Presentation: Historically and architecturally significant attributes of PW and PG

PROPOSED DEVELOPMENT
1075 POMEROY AVENUE
SANTA CLARA, CA.

1075 POMEROY AVENUE
 ALTERNATIVES TO PROPOSED DEVELOPMENT
 SITE PLAN

Figure 2.7 - Second-story windows on *House A* are raised at least five feet above the finished floor, reducing privacy impacts.

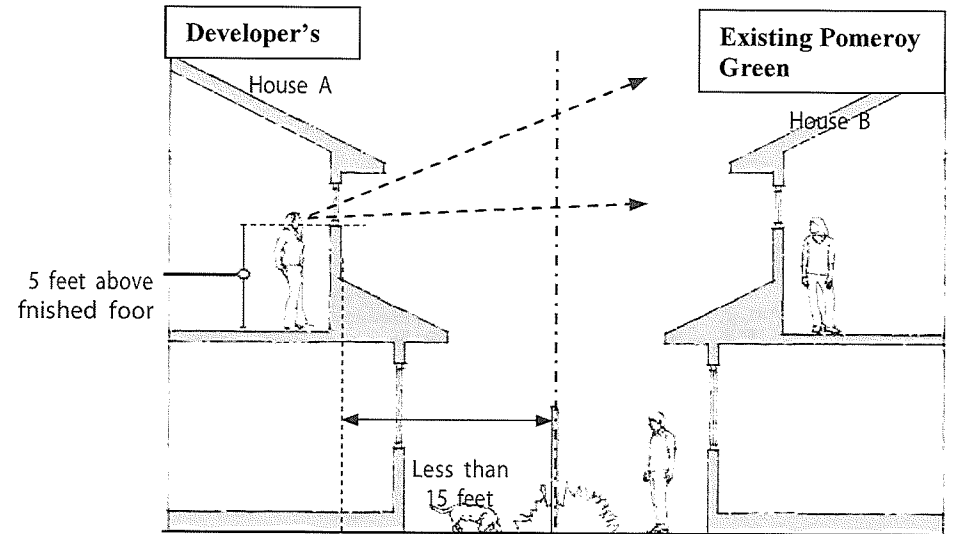
Project provides large 2nd floor windows A1 & B1 that are directly opposite 2nd floor windows in the adjacent Pomeroy Green building Q

Figure 2.10 - Trees and landscaping can block the line of sight into neighboring private spaces.

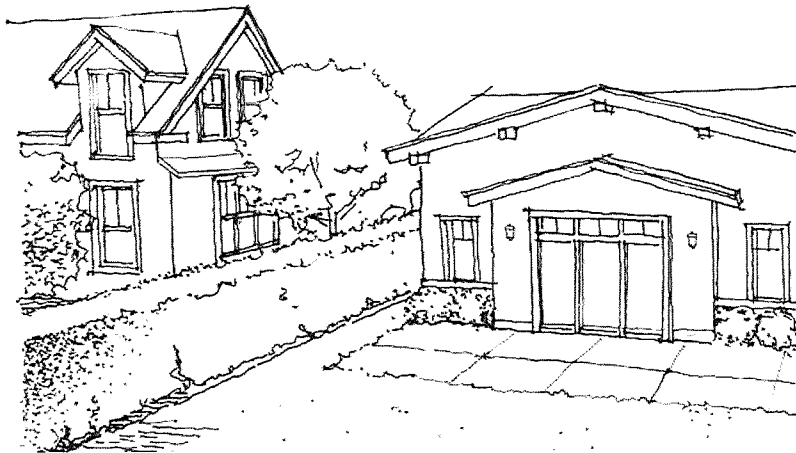
5. On second-floor bathroom windows, use obscure glass where possible and/or substitute a skylight.
6. Install landscaping that may grow to block the line of sight into neighboring side and rear yard whenever feasible. This includes planting trees, and adding landscaping on trellises or arbors that meet Zoning requirements.
(Figure 2.10) 50% line-of-sight due to lack of tree & small tree selection

Figure 4.1 - Block of homes demonstrating setback patterns.

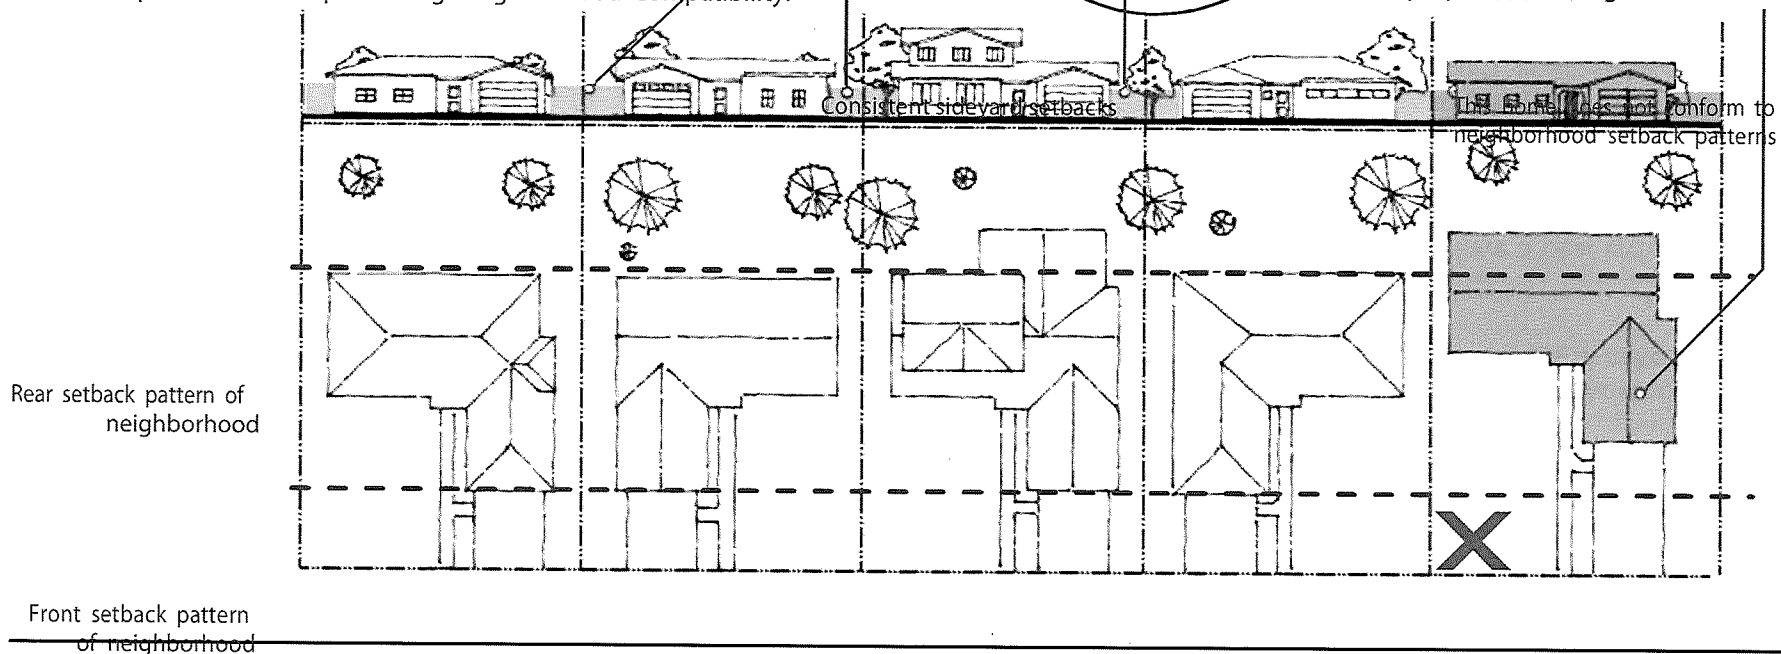
Major Failure

1. The location and orientation of a new home on a lot should be consistent with the prevailing patterns found in the neighborhood. (Figure 4.1)
2. Front and street side yard setbacks should match or not extend beyond that which is typical for the block and appropriate for the scale of the proposed building.

Figure 4.2a - Second-story addition with larger side setbacks to reduce shading of neighboring properties.

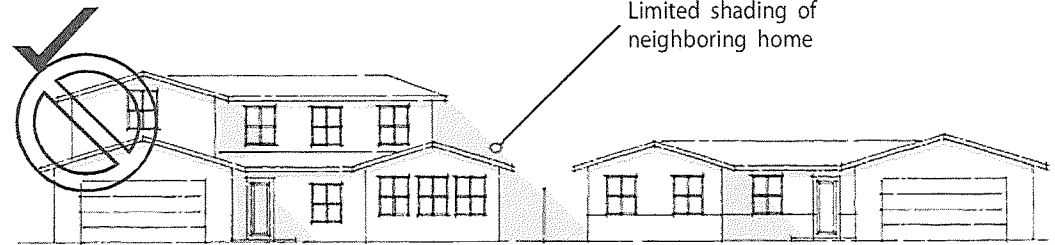
3. Proposed designs should minimize, to the extent possible, shading of adjacent homes and private yards. Impacts of scale, shadow, views, air, and light and other consequences of development upon nearby properties may require use of greater setbacks to provide less shading. (Figure 4.2) **Major Failure**

1075 POMEROY AVENUE
ALTERNATIVE TO PROPOSED DEVELOPMENT
2nd FLOOR PLAN

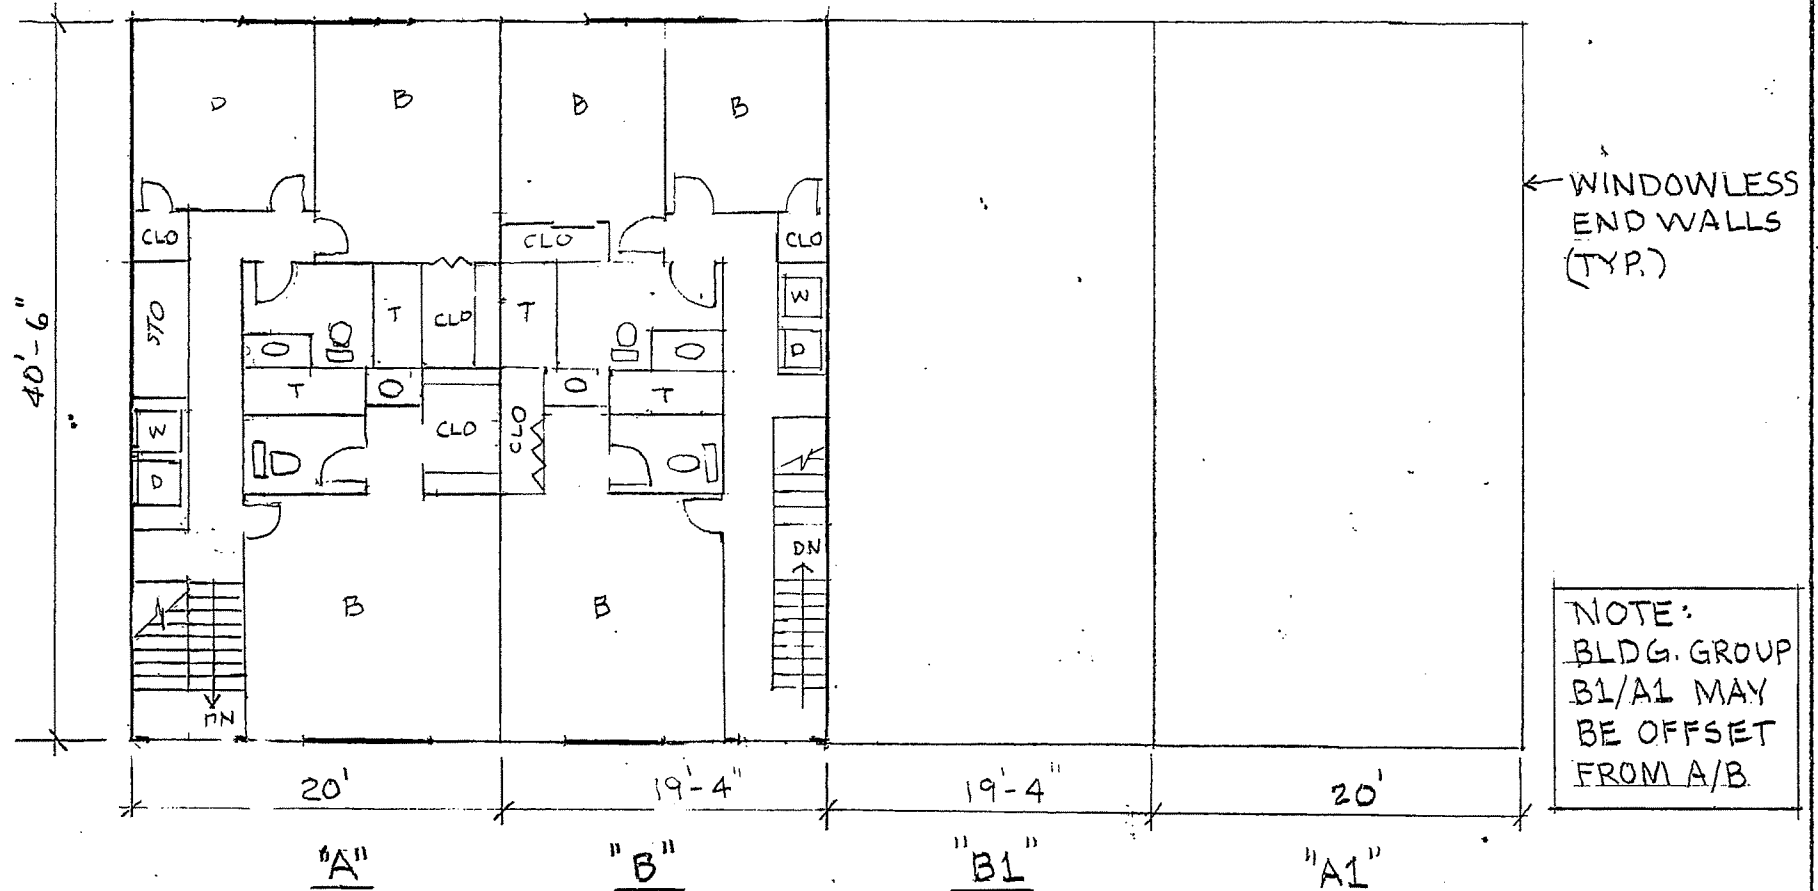
NOTE:
BLDG. GROUP
B1/A1 MAY
BE OFFSET
FROM A/B

Developer's design – street side view of one proposed home

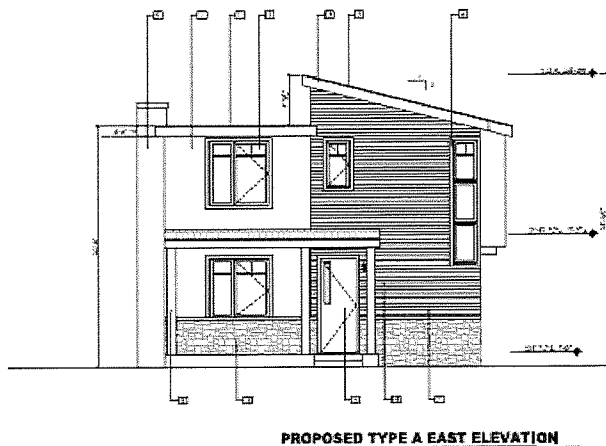
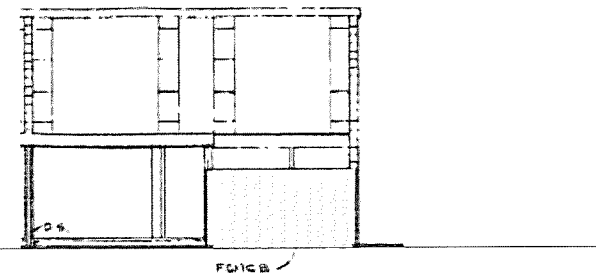
Developer proposed designs violate all the preceding listed City of Santa Clara guidelines! (compatibility with neighboring homes, privacy, material choice, building height, etc.)

Note: These are to scale renditions and demonstrate the size incompatibility that will be apparent if located next to each other.
